**Casino Repairs & Boathouse Renovations at Roger Williams Park**

**Addendum # 1**

**May 13, 2022**

**SECTION 00 9111**  
**ADDENDUM NO. 01****PART 1 PARTICULARS**

FIRST FLOOR PLAN & DOOR SCHEDULE

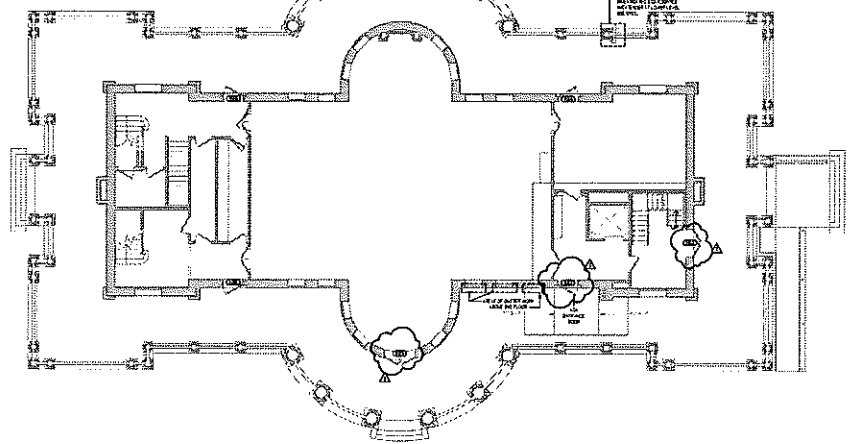
- 5.01 RWP Casino Repairs Sheet A1.1 First Floor Plan & Door Schedule REPLACE sheet with attached dated 05.06.2022.

- 6.02 All pairs of doors on the Casino are existing and undersize in width by today's egress codes. The door schedule lists the pairs of doors #101 at 3' but they are not and do not meet egress or ADA requirements for a single leaf.

- Door widths at openings #101 and #103 are updated in the drawing A1.1 issued with this addendum, per project specifications G.C will be required to field verify all dimensions, existing functions, conditions, and preparations and coordinate to suit opening conditions and to provide proper door operation.

**Response:**
- No changes are proposed to existing door leaf and/or opening widths.
  - Paired doors #101 and #103 are not accessible entrances and do not need to meet ADA requirements.

- Doors are not required to meet current egress codes. Per RISRC Section 302.1.2 conformance of 'Repairs', work shall not make the building less conforming with the building or fire code of the jurisdiction than it was before the repair was undertaken.
